PREST • VUKSIC
ARCHITECTS

June 5, 2014

SUBJECT: PRELIMINARY REVIEW 2014-071: LA QUINTA SQUARE

LA QUINTA COMMERCIAL CENTER

PRELIMINARY SITE PLAN
 0' 15' 30' 60'

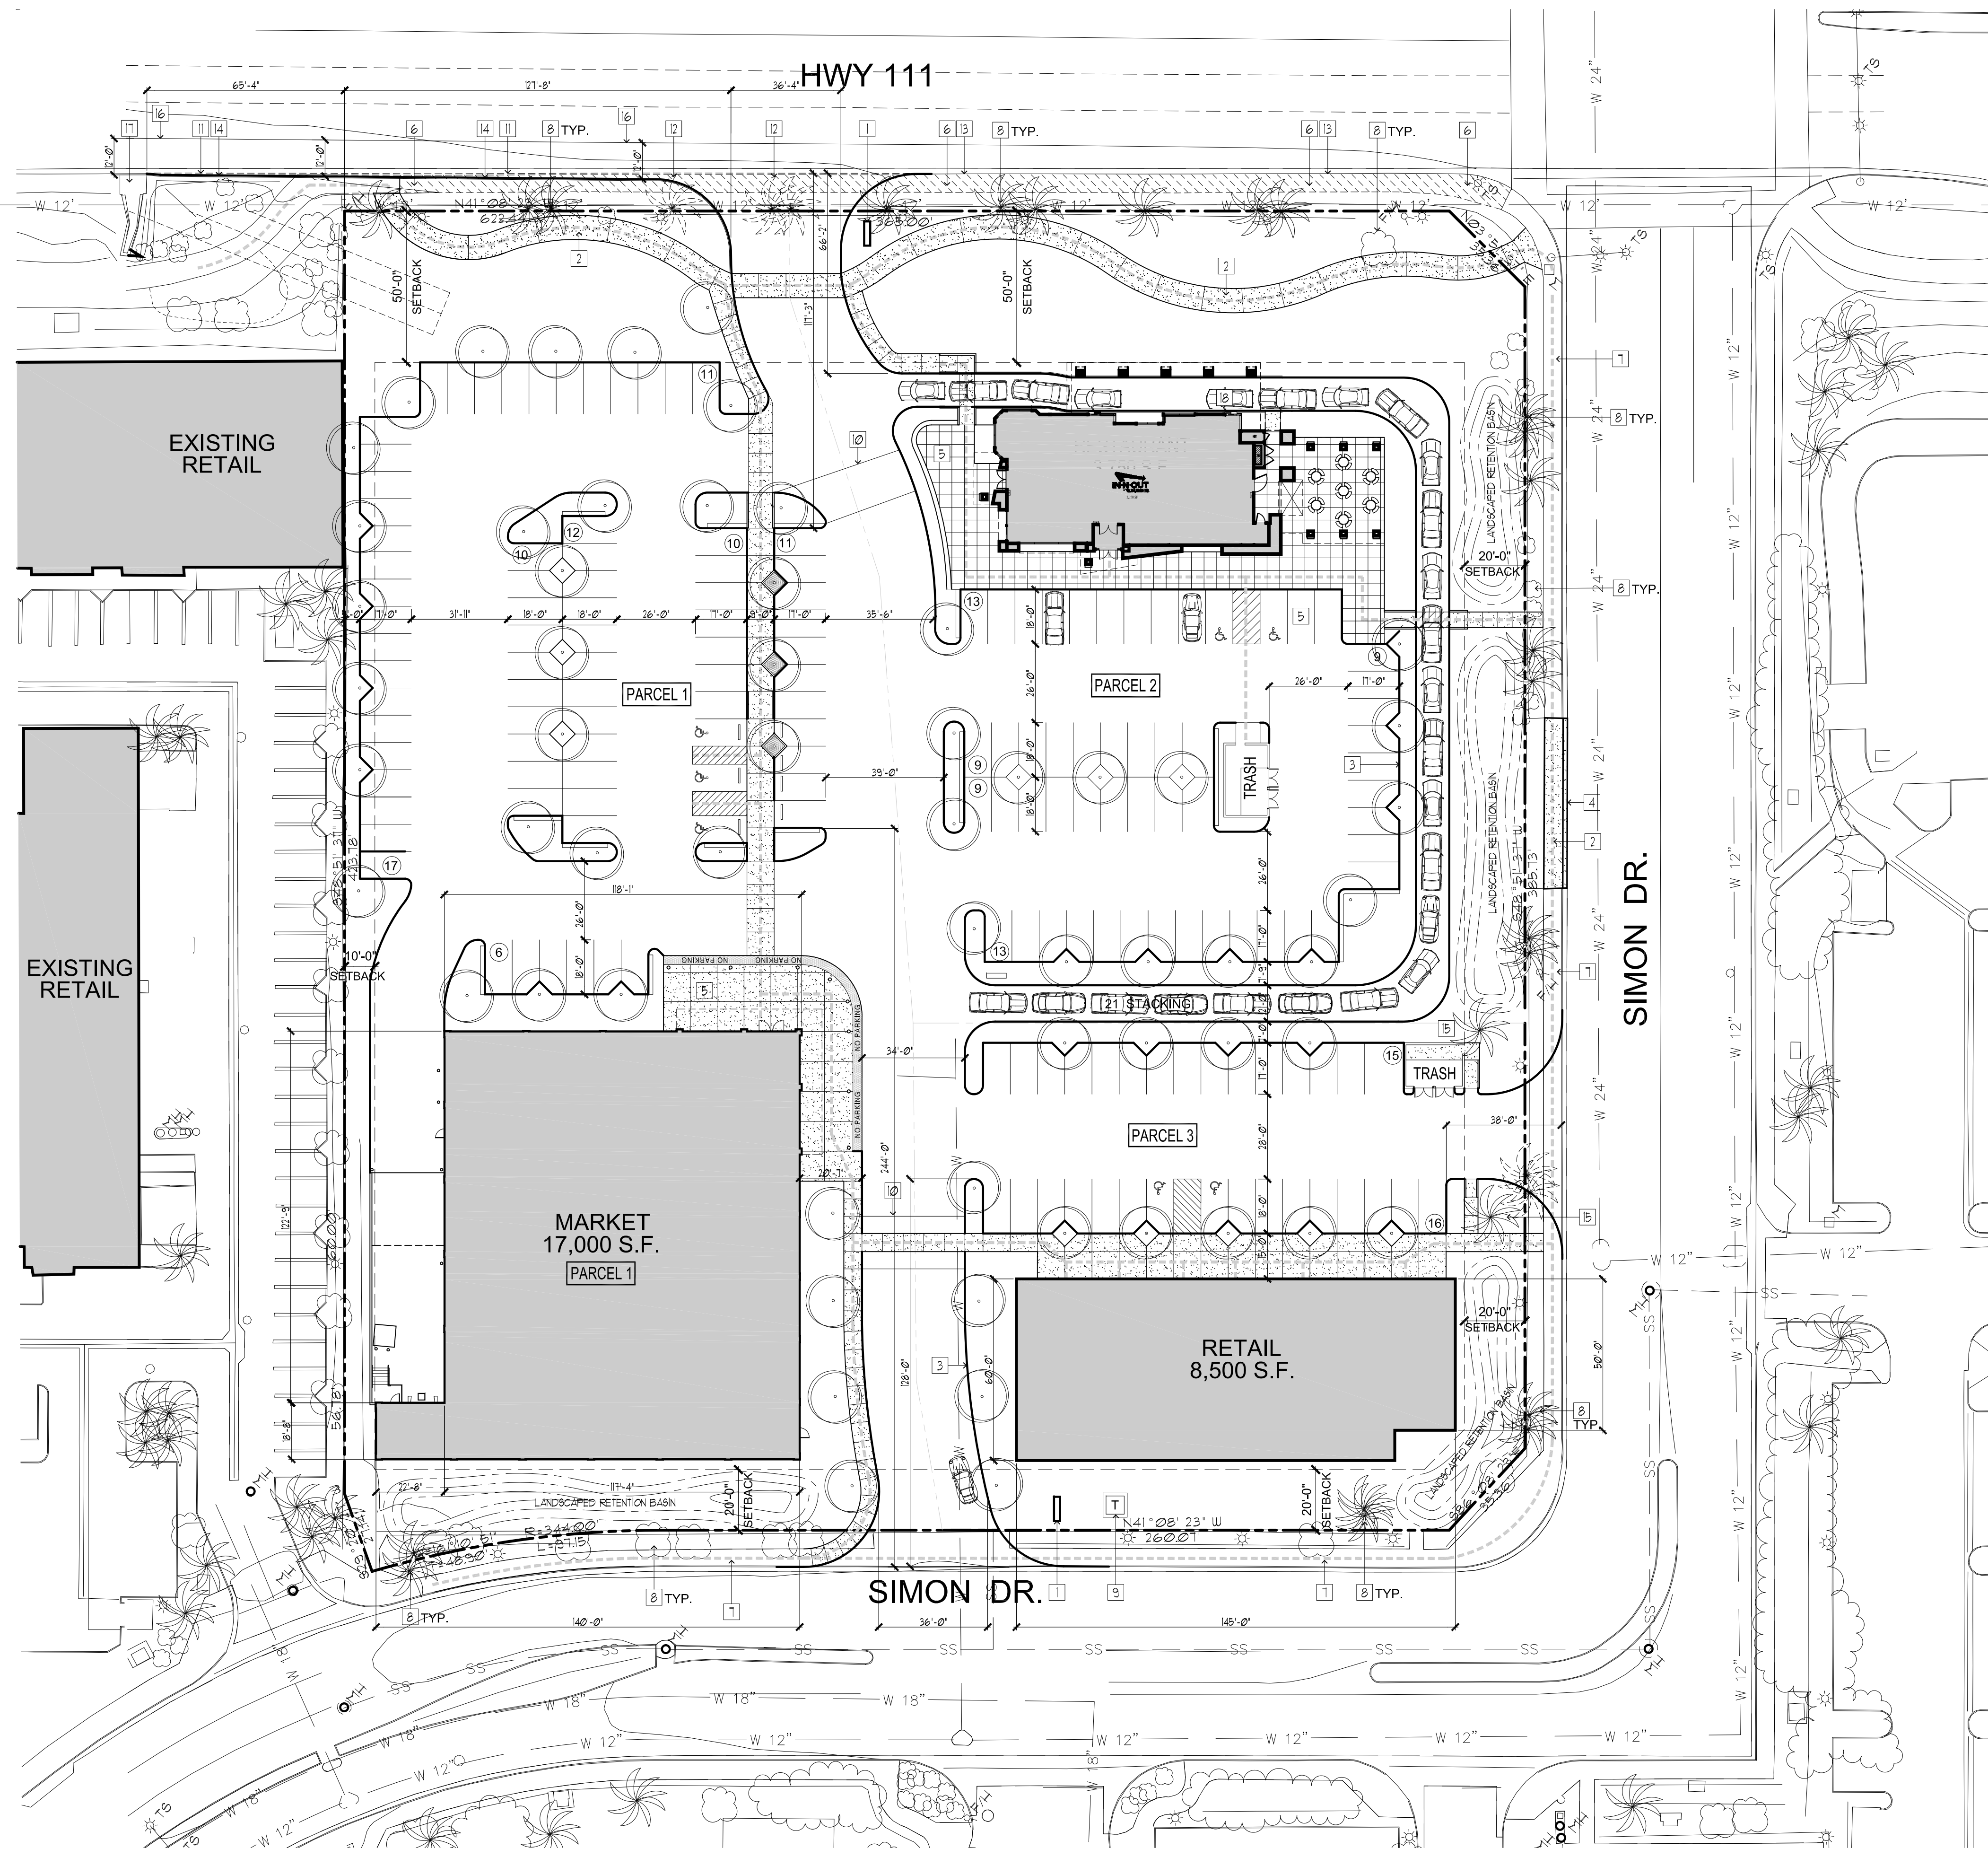
- It is suggested that an access be added to Simon Drive south of Highway 111 in addition to the access that is opposite the Trader Joe's driveway.

- The drive through stacking capacity is measured from the order point and not the pickup window. Experience has shown that the stacking capacity for an In and Out Burger needs to be long enough to accommodate 25 vehicles. Given the limitations of the site. It is strongly recommended that this restaurant be provided with two drive through windows.

Per this comment/suggestion an access drive on to east Simon was considered and added to improve circulation to, from and within the site. See attached site plan. Per the May 15, 2014 meeting with the City it was agreed that the south drive onto Simon needs to remain as shown on the reviewed site plan due to the "right in" from Simon and the existing left turn pocket for those driving east on Simon from Washington Street.

Adding the third drive access at east Simon has done two things: It has improved site circulation and it also provided one more drive thru stacking spaces totaling 21 spaces three times more than the require 7 and 7 additional parking spaces for INO on Parcel 2. Please refer to the enclosed site plan Note 18.

ACCESSWAY EXHIBIT 1

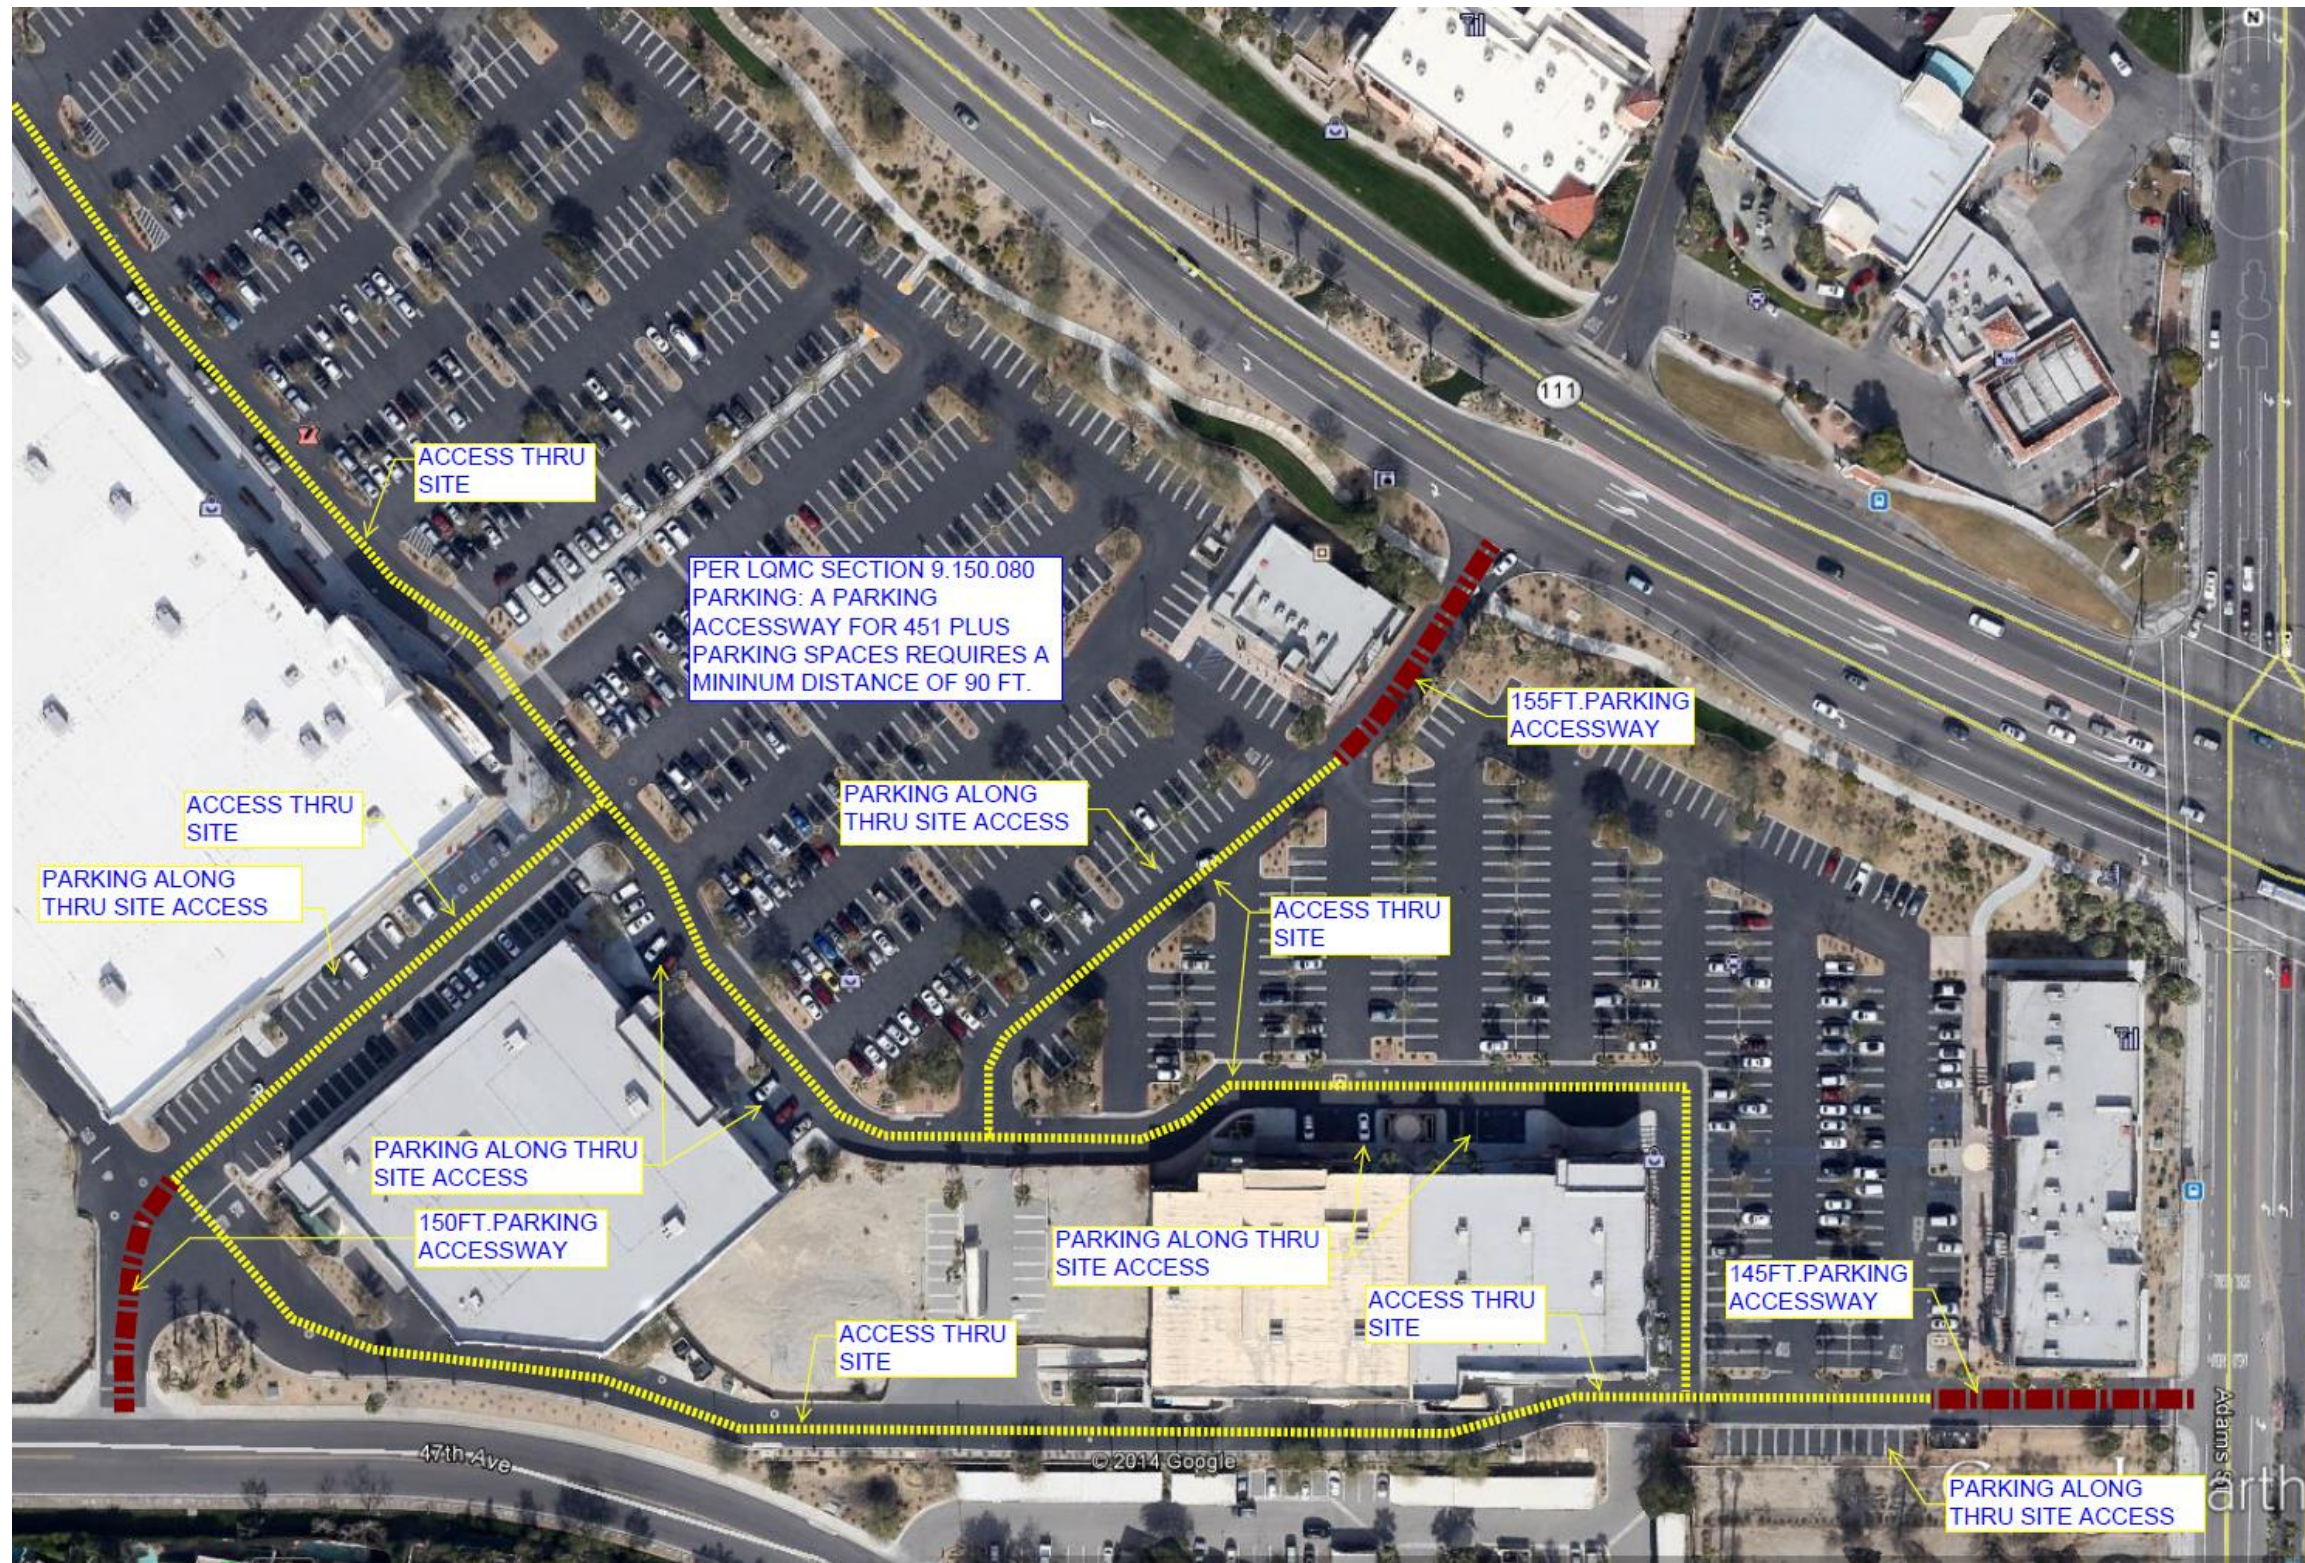
- No parking is permitted on an accessway (LQMC Section 9.150.080). The drive aisle that bisects the project is considered an accessway; therefore, the eighteen parking spaces located along the drive aisle are not permitted.

Please see attached Exhibit 7, La Quinta Square's accessway and access through site and Exhibits 1-6 of Google Earth Aerials showing existing commercial developments and their accessways and accesses through their sites which are similar to La Quinta Square's.
